24 March 2026

Ref: 30N-24-0442-TRP-135121-1

107-123 High Street, Belmont, Geelong

Figure 11: ground floor plan with the recommended wind control measures overlaid.

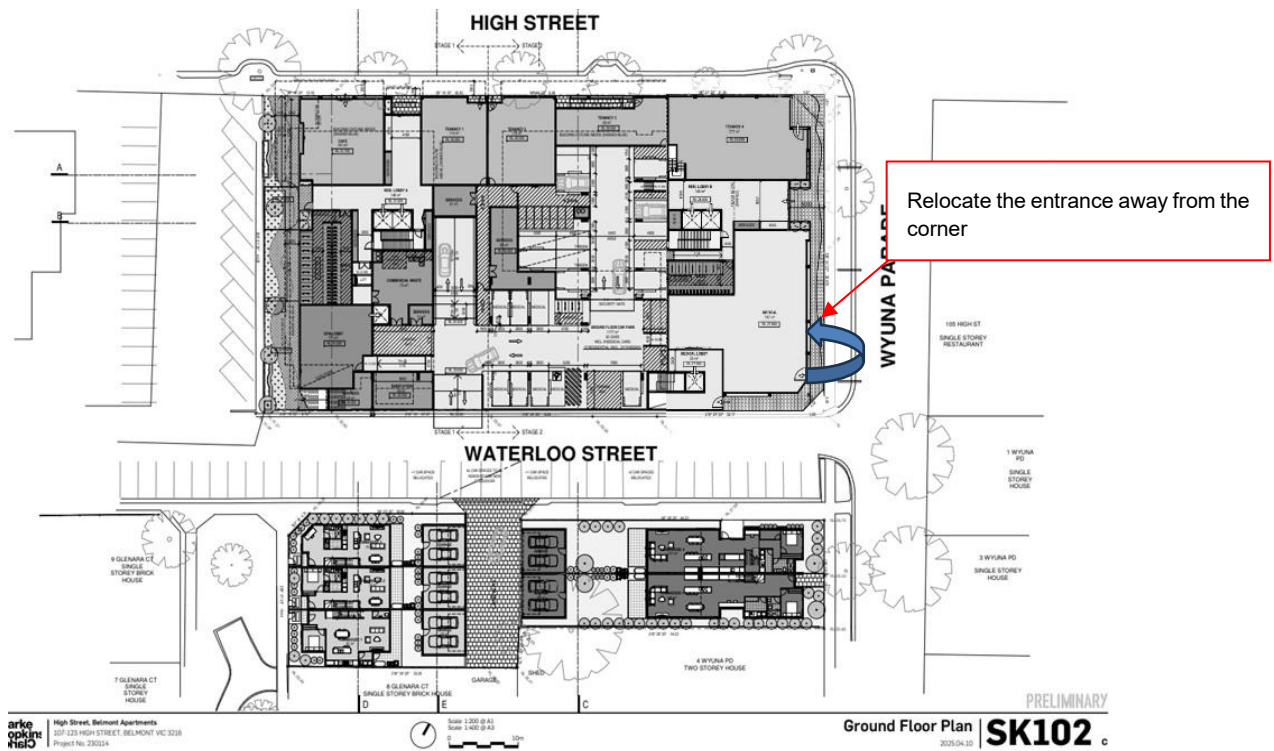
The entrance at the corner might be expected to have high wind conditions. It is recommended to relocate the entrance away from the corner (Figure 11).

Figure 14: Level 9 plan with the recommended wind control measures overlaid.

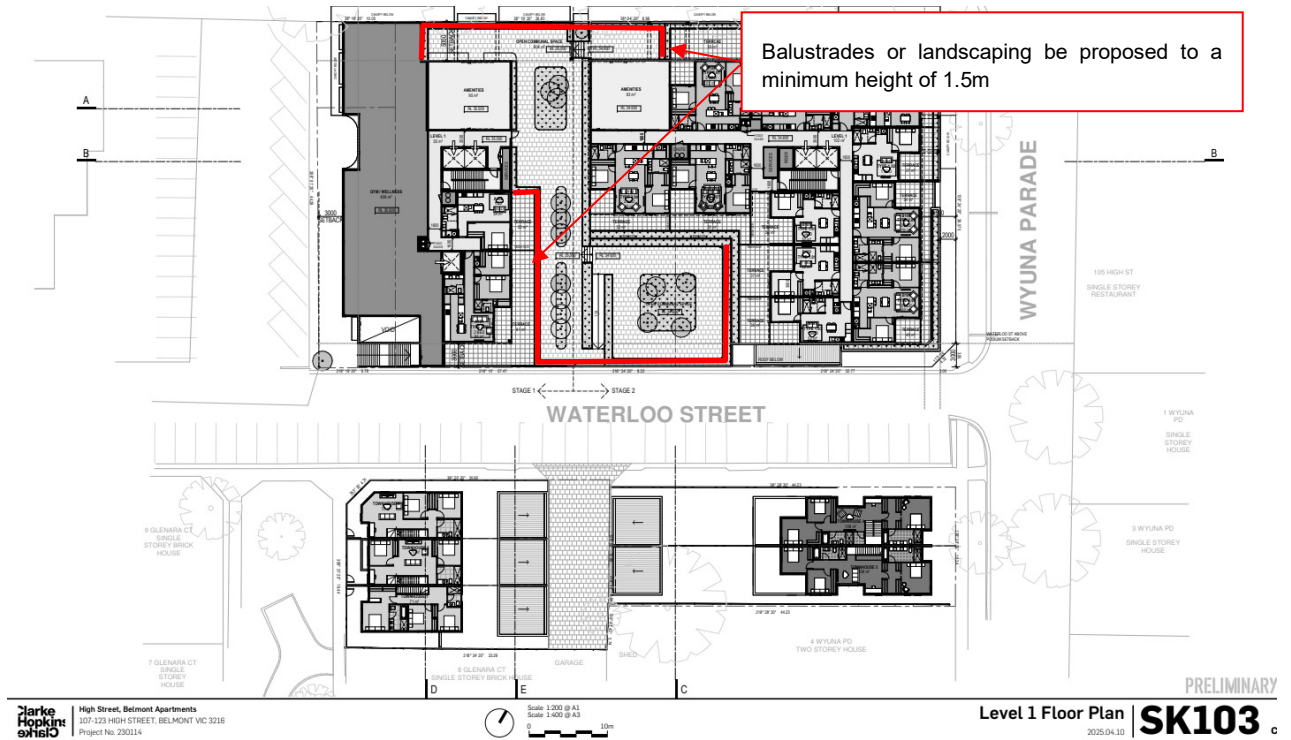
The prevailing north-westerly winds are expected to channel and accelerate onto the Open Communal Space on level 1. This accelerated flow is expected to cause adverse wind conditions. With the inclusion of the 1.5m high impermeable balustrade as shown in figure 14 of the report 30N-24-0442-TNT-102995-1, this adverse wind condition is expected to be mitigate and thus the level 1 Open Communal Space is expected to be suitable for its intended use.
